**Site-Visit Minutes**  
**Solicitation for Walls Repainting at America House**

Minutes from Site-Visit of July 19, 2016, 14:00 – 15:00 at the America House (6 Pymonenko St., Kyiv, Ukraine).

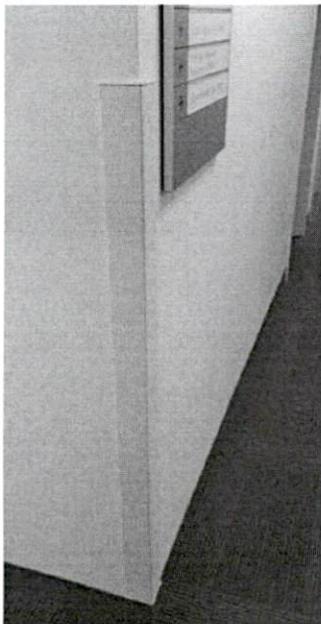
**2) What is the required height of plastic or wooden protective wall corners?**

The required height of protective wall corners is as follows:

- Near the elevator exits: all the way up the walls (from floor to ceiling), but these corners should not be too wide;
- All other walls: 135- 160cm- please see the photo below as an example:
